## MS-9200(C)/E & UDACT-F, and Unimode 200 & UNI•COM or ADT-UDACT Supplement:

**Mounting UDACT-F with MS-9200(C)/E, and  
Mounting UNI•COM or ADT-UDACT with  
Unimode 200**

Document 51139 Rev D 12/12/03 ECN 03-795

**Figure 1: New-to-New Internal UDACT-F Installation (Top View and Side View)**

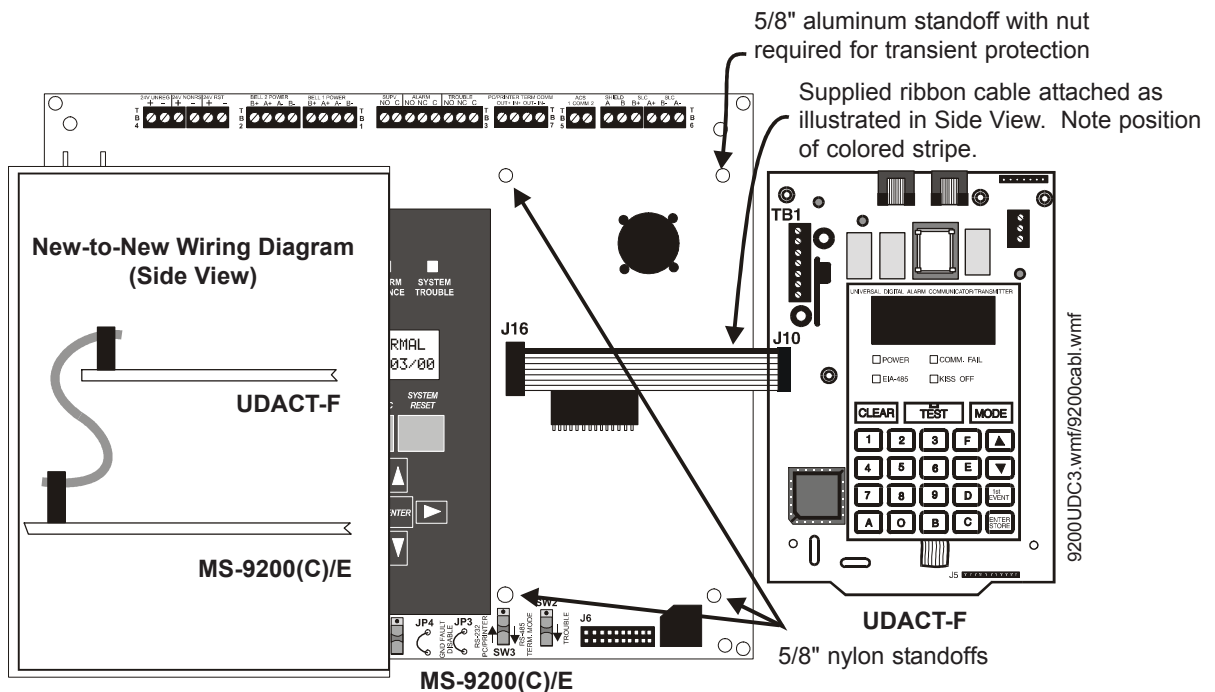
There has been a redesign of the MS-9200(C)/E FACP (Fire Alarm Control Panel) cabinet (effective 11/98) and the UDACT-F (Universal Digital Alarm Communicator/Transmitter) module (effective 2/99). The same changes have been made to the Unimode 200 cabinet and UNI•COM/ADT-UDACT module. Where this document says "MS-9200(C)/E", it also refers to the Unimode 200. Where this document says "UDACT-F", it also refers to the UNI•COM/ADT-UDACT.

Use the 5/8" standoffs when mounting the UDACT-F inside the new version MS-9200(C)/E cabinet. Longer standoffs will cause the FACP cabinet door to make contact with the UDACT-F module, possibly resulting in damage to the UDACT-F. In addition, the new version UDACT-F/UNI•COM/ADT-UDACT module no longer plugs directly into the main circuit board connector J16. Use the ribbon cable shipped with the new UDACT-F to connect J10 on the UDACT-F to J16 on the MS-9200(C)/E main circuit board (refer to Figure 1).

**Figure 4: Connecting New Version of MS-9200(C)/E to Old Version of UDACT-F (Side View & Top View)**

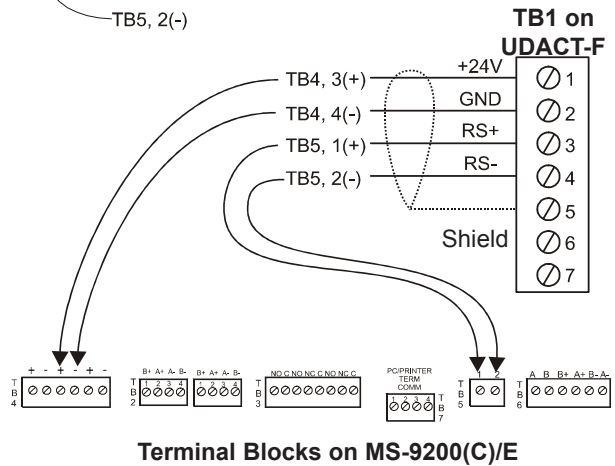
To connect a new MS-9200(C)/E with an old UDACT-F, use Terminal Block Plug 02109 to hard-wire Terminal Block TB1 on the UDACT-F to Terminal Blocks TB4 & TB5 on the MS-9200(C)/E. This plug and the proper 5/8" standoffs required for the new cabinet are included in upgrade kit DACT-UG.

**Figure 5: Connecting Old Version of MS-9200(C)/E to New Version of UDACT-F (Side View & Top View)**

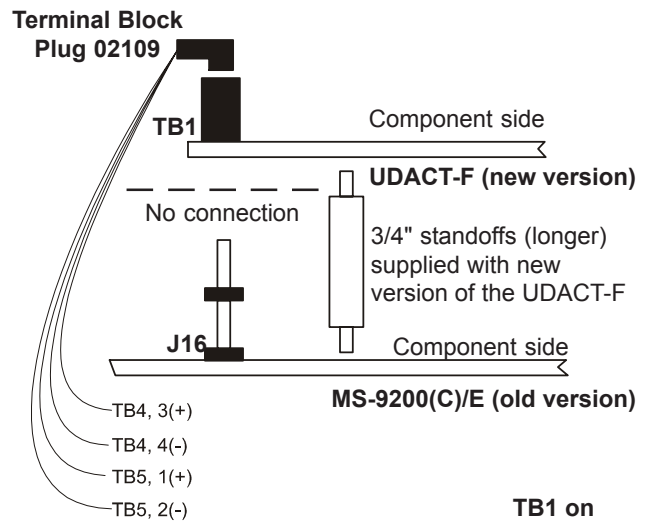
To connect an old MS-9200(C)/E with a new UDACT-F, use Terminal Block Plug 02109 to hard-wire

Terminal Block TB1 on the UDACT-F to Terminal Blocks TB4 & TB5 on the MS-9200(C)/E. This plug and the proper 3/4" standoffs used for the old cabinet are shipped with the new UDACT-F.
